UNITED STATES PATENT AND TRADEMARK OFFICE

APPLICATION NO.	FILING DATE	FIRST NAMED INVENTOR	ATTORNEY DOCKET NO.	CONFIRMATION NO.
10/817,078	04/02/2004	Brendan Doorhy	27726-95741	2149

Office Action Summary	Application No. 10/817,078	Applicant(s) DOORHY ET AL.	
	Examiner John P Fitzgerald	Art Unit 2856

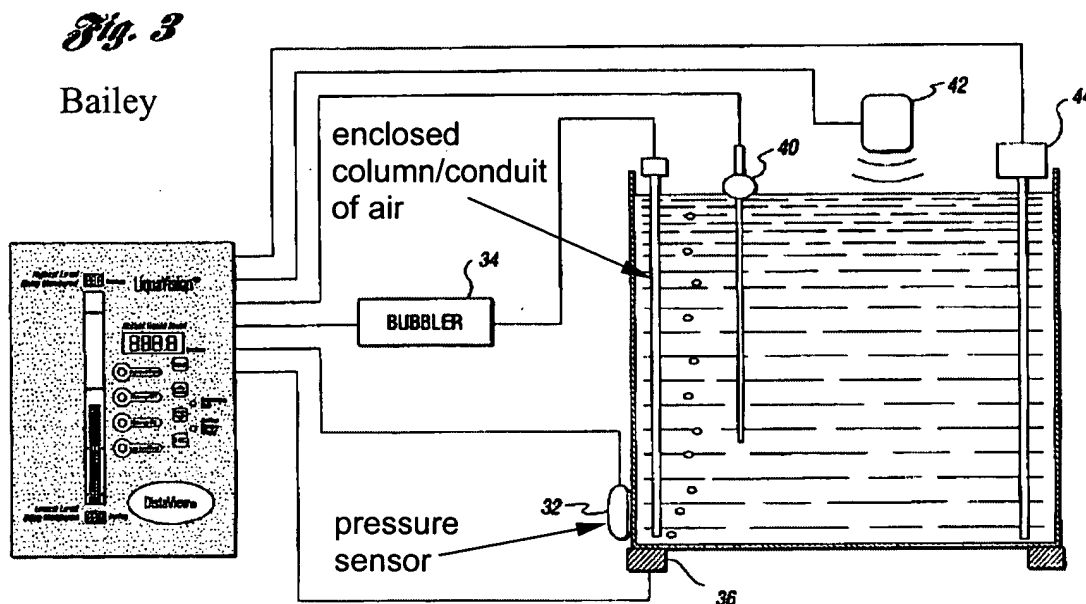
5. Claim 25 is rejected under 35 U.S.C. § 102(b) as being anticipated by US 5,705,747 to Bailey. Bailey discloses a method of providing an indication of the level in a beverage dispenser (container, storage tank, vessel or equivalents) (Figs. 1-8d) including placing an enclosed column of air (bubbler (34)) in communication with the beverage/liquid in the dispenser so as to place air under pressure of the beverage/liquid; placing a pressure sensor in communication with the column of air, the sensor producing a signal related to the air pressure (Bailey: col. 3, lines 5-10); and communicating the signal to a display (see Fig. 3 below), the display indicating the level of fluid in the dispenser.
